Access Compliance Report

Public Rights-of-Way

(Curb Ramps)

Intersection ID: 12333	Main Street: N_BREVARD_ST	Cross Street: E_7TH_ST	Location: W
ADA ID: CF820B3EBA43	Ramp Type: Perp	Initial Pass/Fail: Pass	Overall Compliance: No
Severity Score: 0			
Codes/Mitigation Info/Possible Solution		Field Measurements/Component Compliance

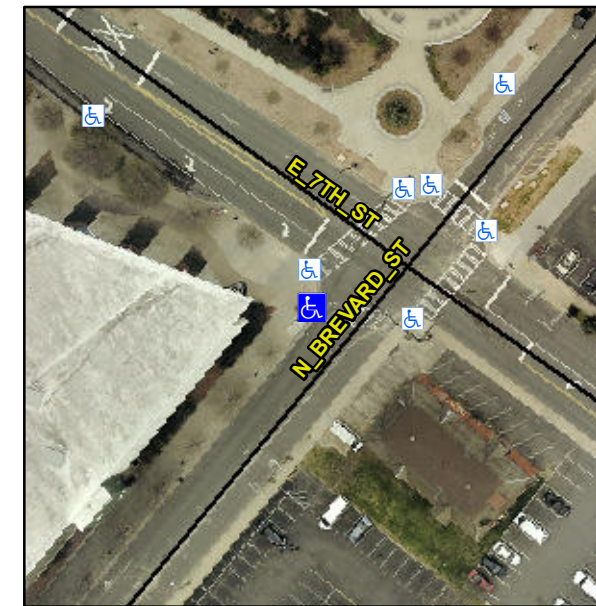
Not Found, R304.2.2-Perp, R304.3.2-Para, R304.5.3

Compliance	Description	Data	Compliance	Description	Data
N/A	Ramp Length (in)	60.0	Yes	Ramp Slope (%)	7.0
Yes	Ramp Width (in)	48.0	Yes	Ramp XSlope (%)	0.3
N/A	Flare Type LT	Sloped	N/A	Flare Type RT	N/A
N/A	Flare Slope LT (%)	3.5	Yes	Flare Slope RT (%)	5.1
N/A	Flare Traversable LT?	No	N/A	Flare Traversable RT?	Yes
Yes	Landing Length (in)	48.0	Yes	DWS Provided?	Yes
Yes	Landing Width (in)	48.0	Yes	DWS Contrast?	Yes
No	Landing Slope (%)	2.9	Yes	DWS Length (in)	24.0
No	Landing X Slope (%)	2.1	Yes	DWS Full Width?	Yes
N/A	Landing Curb? (Y/N)	No	Yes	DWS Offset (in)	0.0
N/A	Shared Landing?	No			
Yes	Gutter Ponding?	No	Yes	Gutter Slope (%)	1.9
Yes	Gutter Lip Ht (in)	0.0	Yes	Gutter X Slope (%)	0.1
N/A	Painted X Walk1?	Yes	N/A	Painted X Walk2?	N/A
	X Walk 1 Direction	To SE		X Walk 2 Direction	N/A
N/A	X Walk 1 Width (in)	110.0	N/A	X Walk 2 Width (in)	N/A
	X Walk 1 Slope (%)	2.5		X Walk 2 Slope (%)	N/A
	X Walk 1 X Slope (%)	0.4		X Walk 2 X Slope (%)	N/A

Yes	Ramp inside XWalk1?	Yes	N/A	Ramp inside XWalk2?	N/A
	Road Slope (%)	N/A	N/A	Clear Space?	Yes
	Road X Slope (%)	N/A	N/A	Clear Space to XWalk (in)	N/A
Yes	Any Obstructions?	No	Yes	Storm Grate/Utility Hazard?	No
	Obstruction Type			Storm Grate/Utility Type	
		N/A			N/A
			Yes	Surface Condition? (G/P)	Good

Remove & Replace Entire Ramp.

Total Cost: \$ 1850.00
